From: Thomas Larson <tommy@teronomy.com>
Sent: Friday, October 10, 2025 11:46 AM
To: Sumwalt, Orrin; Eileen Suhm
Cc: Tony Larson; Paul Van Henkelum
Subject: [External] Self storage submittal
Attachments: Doc-2025-1003 Review Comments_Teronomy Storage PDD Amend - FDP.pdf; I-43 Storage turing Radii.pdf; The Lofts Site Plan 9-11-25.pdf; THELOFTSBASEPLAN100725.1 LandscapePlan revisions.pdf; thumbnail_IMG_5955.jpg; 1901420- SITE PLAN-10-09-2025.pdf; Teronomy SelfStorage PDD Amendment COMMENTS.docx; 55C0C195-378A-4FD9-B6ED-F0ED81CFCB6C.jpeg; 30B3FAB7-E8AB-4789-9769-896D5C12A182.jpeg; 7F7D674C-D153-4D15-A0F0-62107E28E3C1.jpeg; 3C7DFD9D-3C39-4723-8988-7450445AEAA0.jpeg

TO: Paul Van Henkelum, PE, PLS (Teronomy Builders)
 FROM: Orrin Sumwlat, AICP Planning Consultant
 DATE: October 3, 2025
 RE: Review Comments
 Teronomy Self-Storage: PDD Amendment - FDP

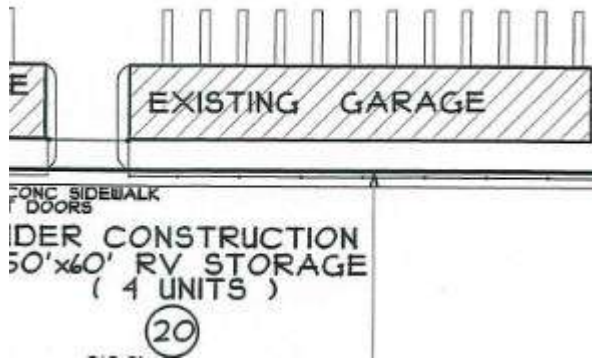
4. The Architectural Site Plan doesn't depict angled parking spaces east of Building #12, while the Engineer's Site Plan does. Please rectify this discrepancy.

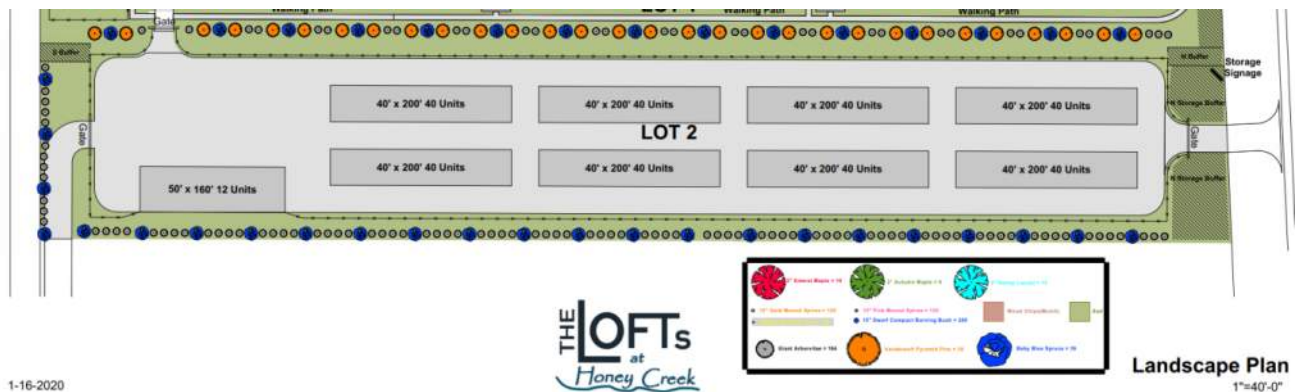
- Please submit new turning movements to demonstrate how Village emergency vehicles will be able to maneuver through the site, including the cross-access to the adjacent Honey Creek Lofts Apartments development.

Incomplete. The document labeled "The Lofts Site Plan Turning Radius" appears to be a copy of the Site Plan and doesn't depict the requested turning movements. Please submit a revised plan addressing this.

6. The approved site plan included turning radius. We included a copy in this resubmittal.

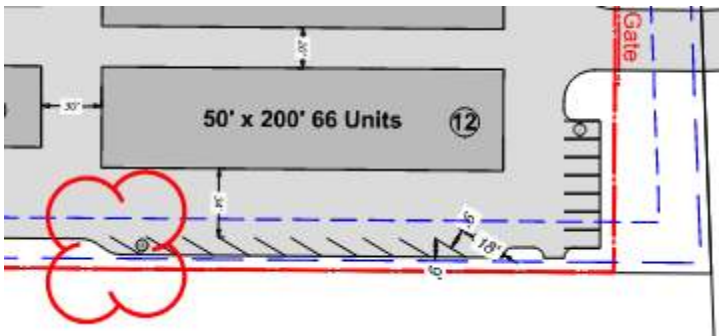
- The proposed landscape plan depicts the north storage buffer and south storage buffer plantings but doesn't depict the remainder of the landscaping. The plan below was provided as part of the GDP submittal, which was in the packet for the February 10, 2020, Plan Commission meeting. Please clarify.

However, Foth has the following recommendations for the landscaped area between the north and south buffer areas.

- Please include a greater diversity of species (Only 3 depicted – Norway Spruce, Kentucky Coffeetree and Blanc Double de Coubert Rose)
- More depth to the plantings (i.e., staggered plantings vs. in a row)

8. We attached a Revised landscape plan in this submittal.

SELF STORAGE SITE PLAN

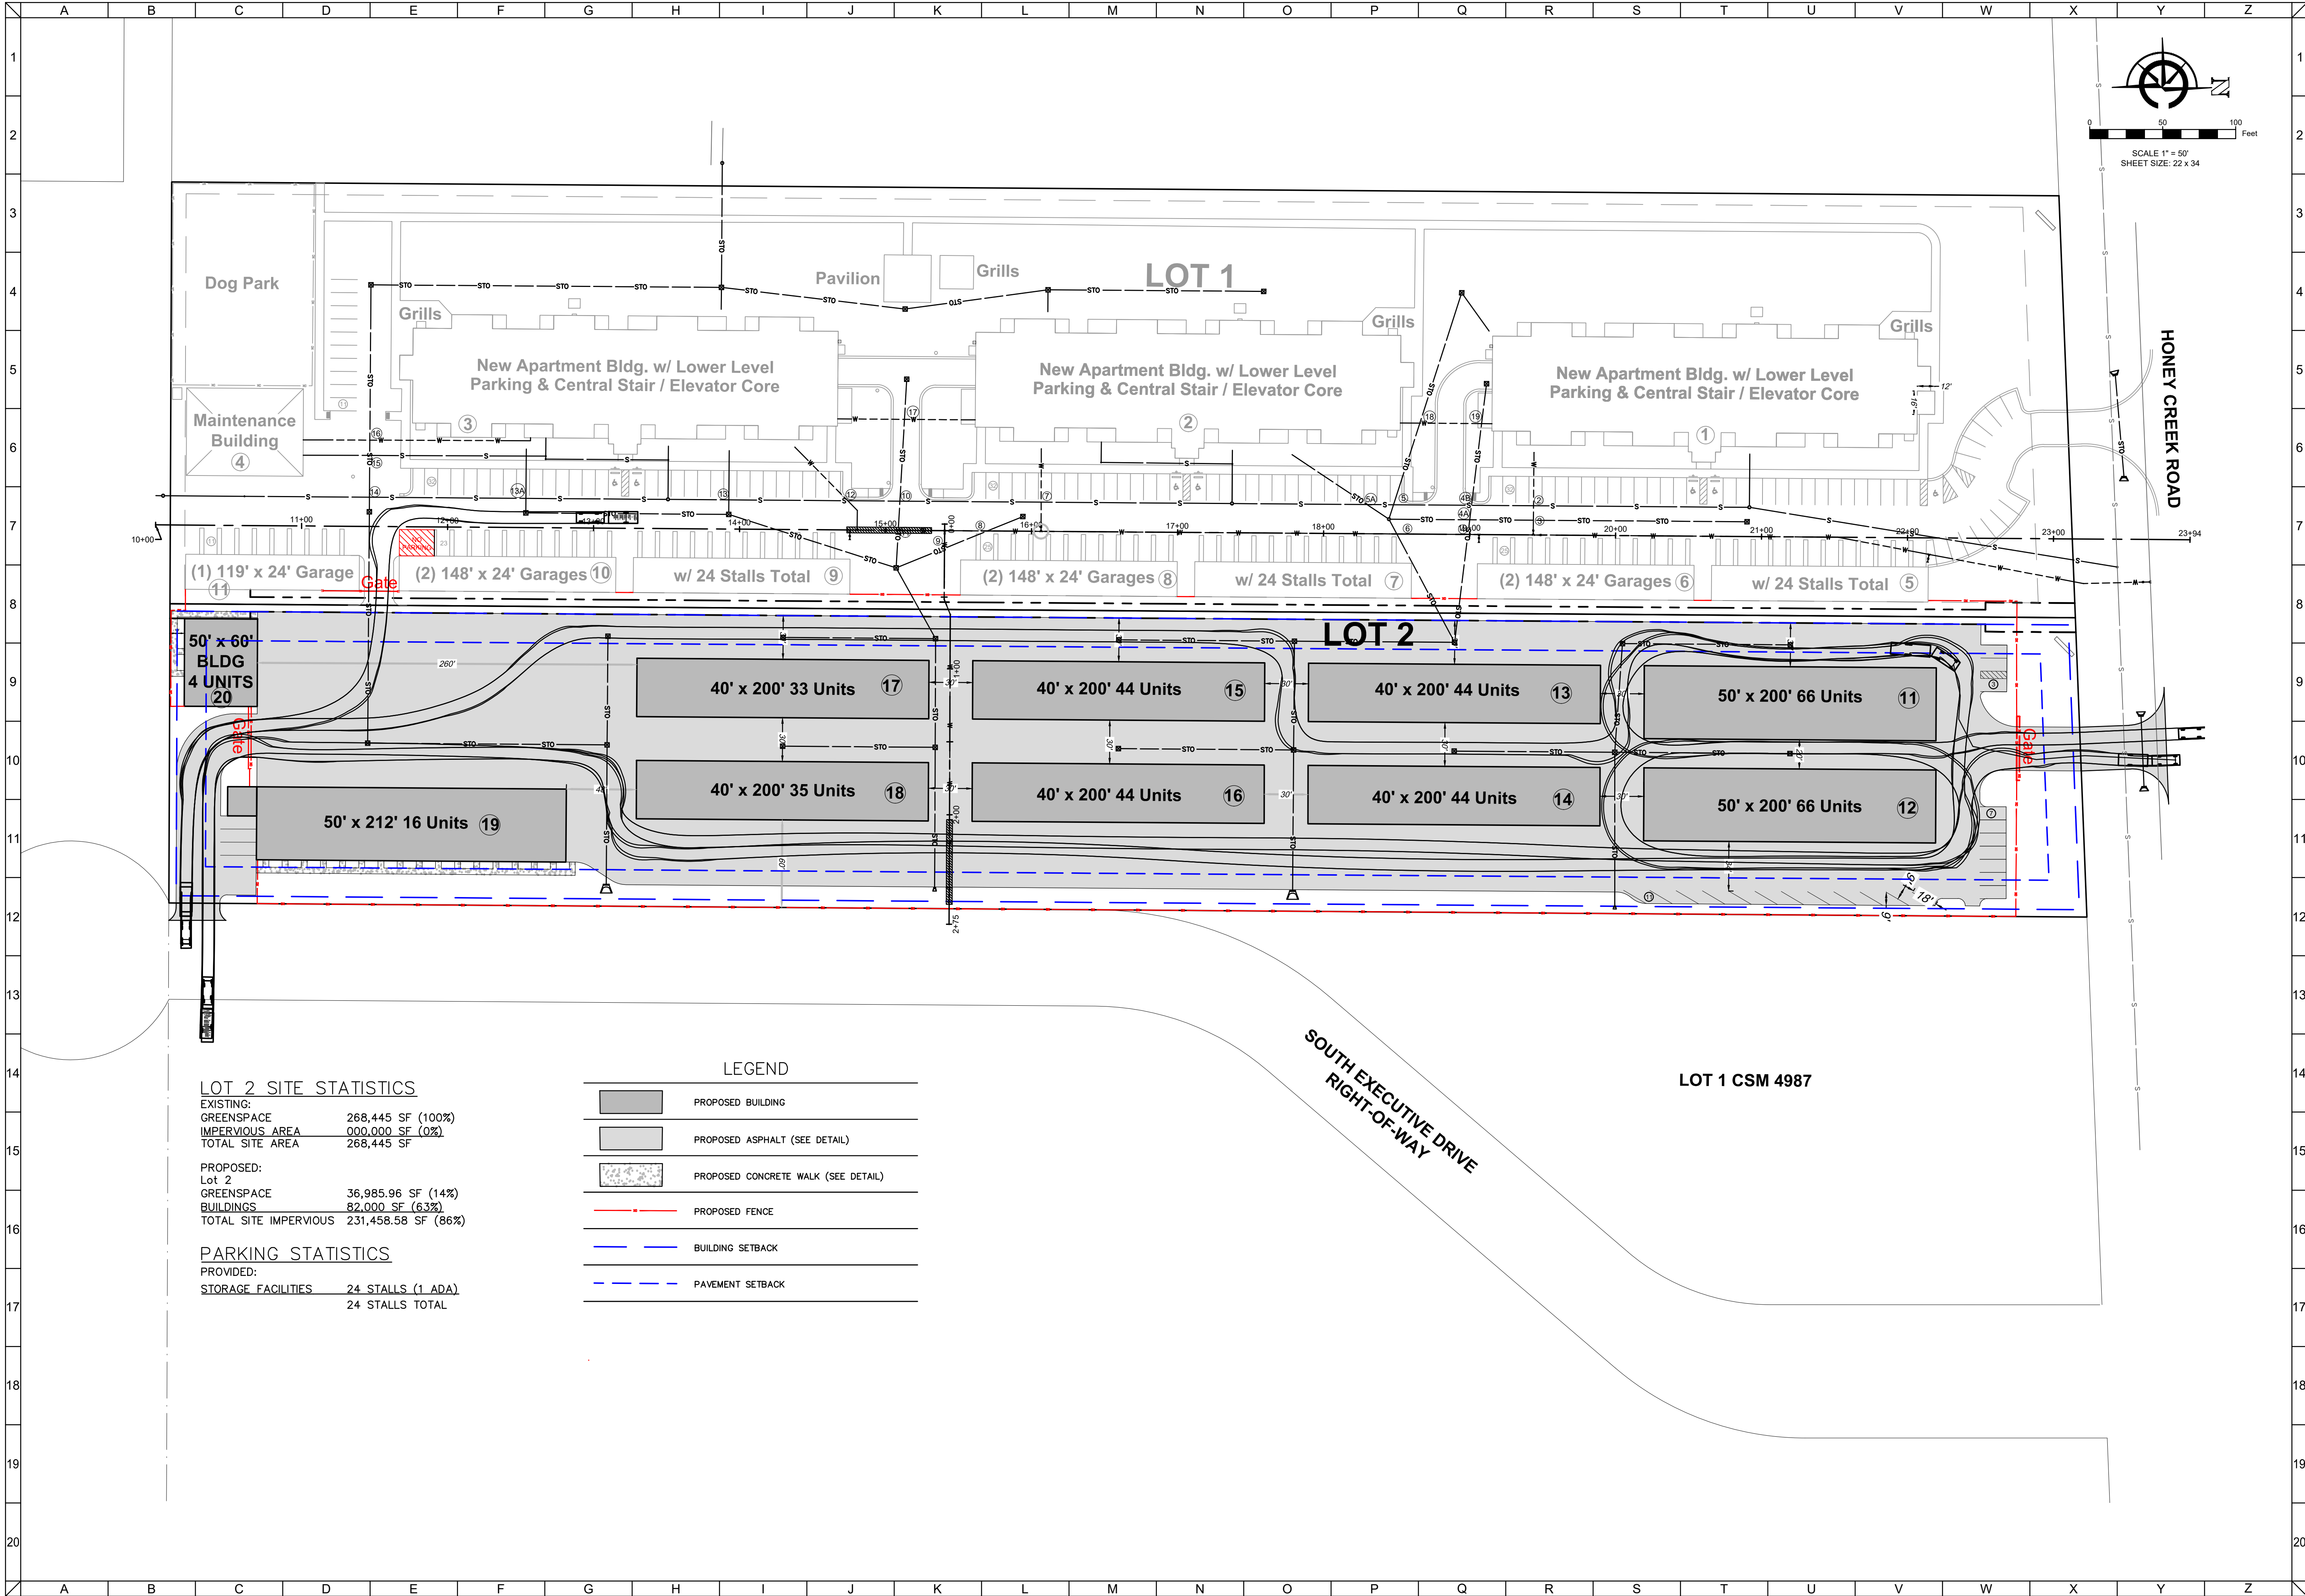
17. Please verify the greenspace and impervious surface calculations, as these appear to be off. By the Village Engineer's rough calculation, there appears to be ~80% impervious surface.

18. Please add a building coverage calculation to the Site Plan.

17. We added calculations for greenspace and impervious ratios on the site plan.

18. We added building coverage ratio calculations to the site plan.
